UNITED STATES PATENT AND TRADEMARK OFFICE

| APPLICATION NO. | FILING DATE | FIRST NAMED INVENTOR | ATTORNEY DOCKET NO. | CONFIRMATION NO. |
|-----------------|-------------|----------------------|---------------------|------------------|
| 09 725,470 | 11/30/2000 | Sang-Duk Lee | 6192.0169.AA | 1695 |

Office Action Summary

DETAILED ACTION

FIG. 2

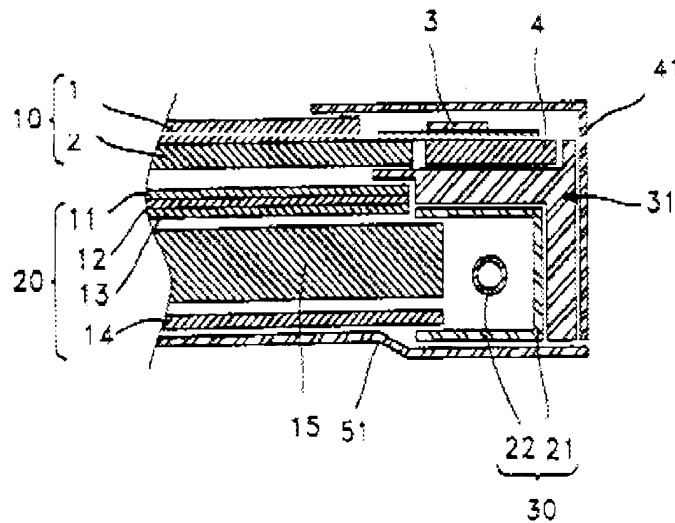
As to claims 1-4 and 27, Lee discloses in Figure 2 a liquid crystal display (LCD) device, comprising: a liquid crystal display panel, 1 and 2, and a flexible printed circuit (not labeled item between 2 and 3), attached to said liquid crystal display (LCD) panel,

for applying driving signals to said liquid crystal display panel; a light guide plate and lamp assembly, 15 and 30, (Applicant's back light assembly) for providing a light to said LCD panel; a mold frame for receiving said liquid crystal display panel and said back light assembly; a chassis, 41, coupled to said mold frame, for fixing said liquid crystal display panel and said back light assembly to said mold frame.

Lee does not explicitly disclose a support means for supporting said flexible circuit board towards said mold frame.

**FIG. 4**

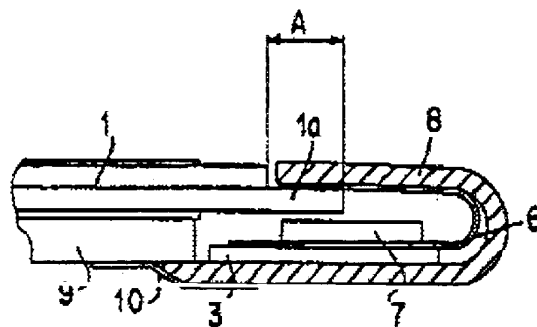
Hashimoto discloses (summary of the invention, col. 2, line 31 through col. 3, line 26) an embodiment shown in Figure 4 (col. 5, line 18 through col. 7, line 52).

Figure 4 of Hashimoto shows a liquid crystal display panel comprising: a flexible printed circuit, 6, which is attached to the liquid crystal display panel, for applying driving signals to said liquid crystal display panel which is curved into a recess which is deeper in the upper end of the outer side to receive a protruding portion, 7, in order to minimize weight and size (summary of the invention, col. 2, line 31 through col. 3, line 26) and to protect the circuits (col. 5, lines 4-17); and a frame member, 8, that has a moderate level of resiliency for nipping the liquid crystal display panel, 1, and the circuit board, 3, (col. 5, lines 58-68) (Applicant's support means for supporting the flexible circuit board towards the mold frame) to provide greater durability and resistance to vibration and impacts.

Hashimoto is evidence that ordinary workers in the art of liquid crystals would find the reason, suggestion, or motivation to add a flexible printed circuit board curved into a recess which is deeper in the upper end of the outer side to receive a protruding portion, and a support means to protect the circuits and to provide greater durability and resistance to vibration and impacts.

Therefore, it would have been obvious to one having ordinary skill in the art of liquid crystals at the time the invention was made to modify the LCD of Lee with the flexible printed circuit board curved into a recess which is deeper in the upper end of the outer side to receive a protruding portion of Hashimoto and the support means of Hashimoto to protect the circuits and to provide greater durability and resistance to vibration and impacts.
